# Manual 12, Balancing Operations

## Revision 57 – Annual Review

PJM Operating Committee  
April 9, 2026

## **Revision 57 (05/26/2026):**

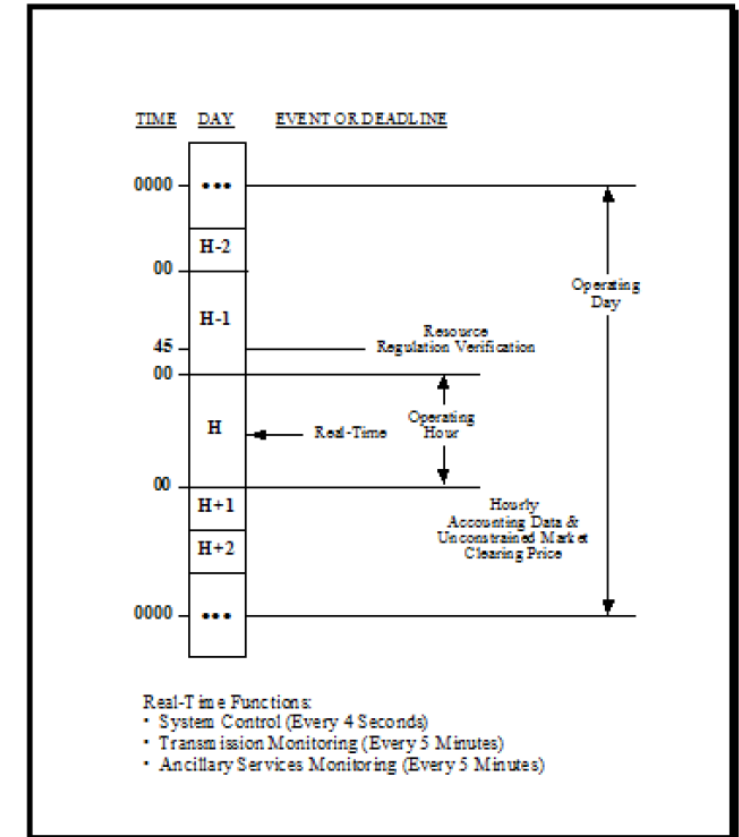
- Updated and reordered references:

- NERC Operating Manual
- [PJM Manual 1, Control Center and Data Exchange Requirements](#)
- [Transmission Operations](#) ~~PJM Manual 3,~~
- PJM Manual 10, [Pre-Scheduling Operations](#)
- PJM Manual 11, [Energy & Ancillary Services Market Operations](#)
- [PJM Manual 13, Emergency Operations](#)
- PJM Manual 28, [Operating Agreement Accounting](#)
- ~~PJM Manual 13, Emergency Operations~~
- [Regional Transmission and Energy Scheduling Practices](#)

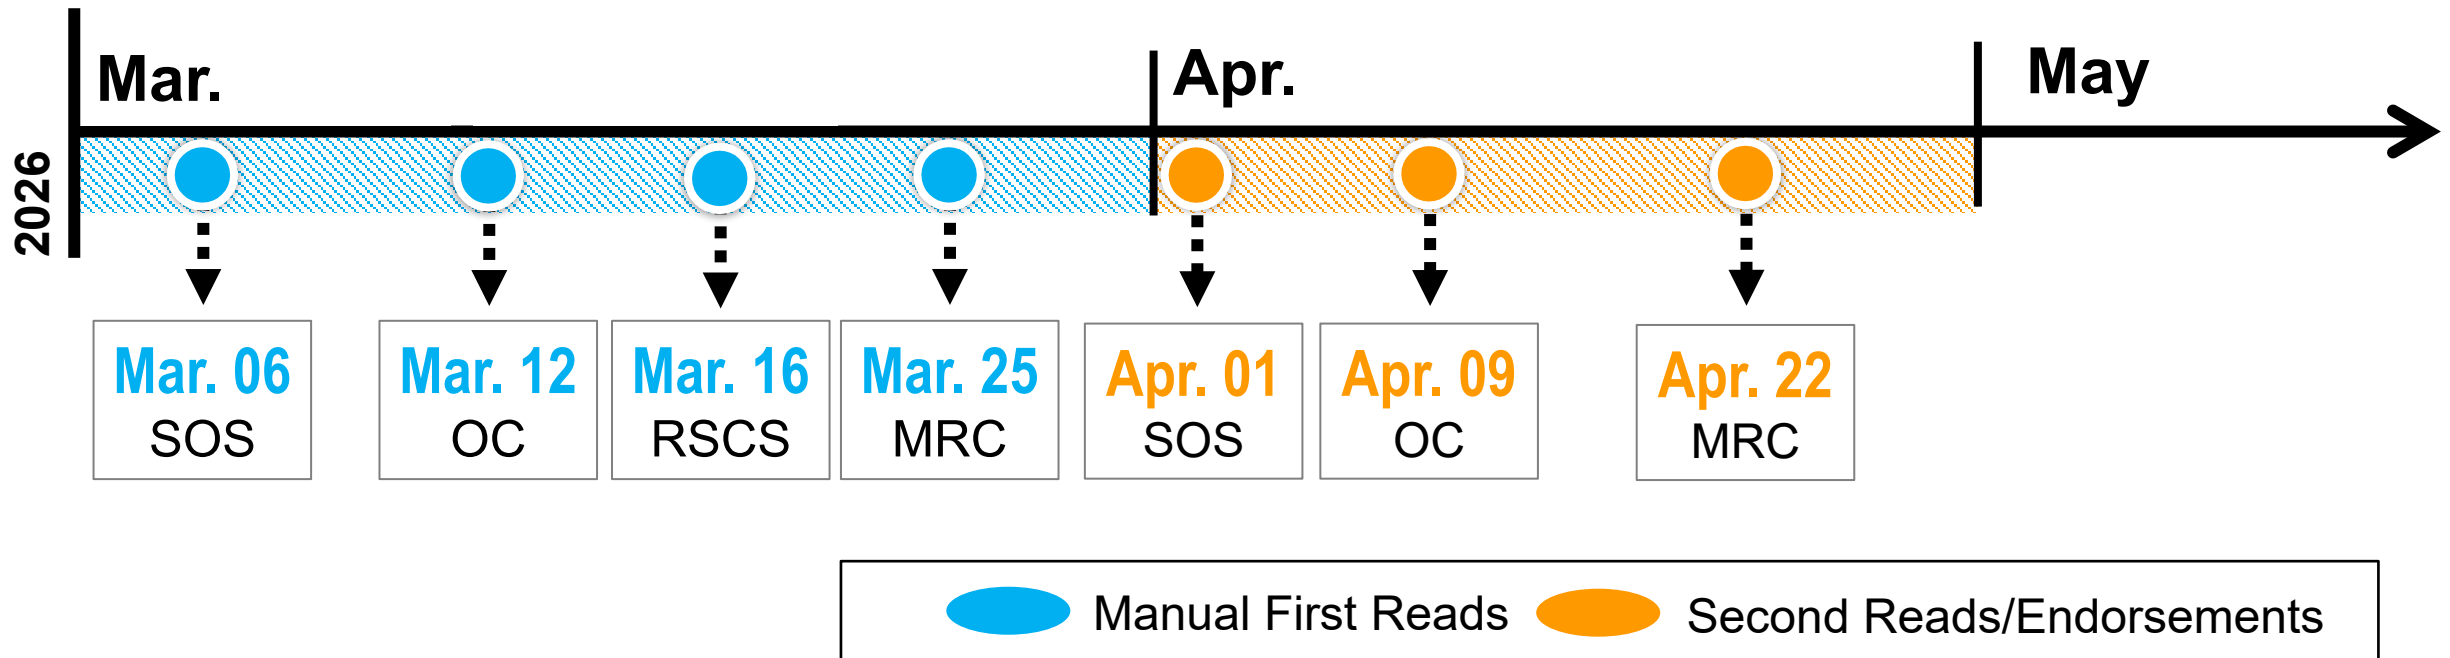
- Renamed Section 4.2 from Shared Reserves to Simultaneous Activation of Reserves (NPCC)
- Changed shared reserves to activated reserves in Section 4.2
- Removed specific control zones in Section 4.2

Currently, payback MWh are not required for NPCC Simultaneous Activation of Reserves~~Shared-Reserve~~ Events.
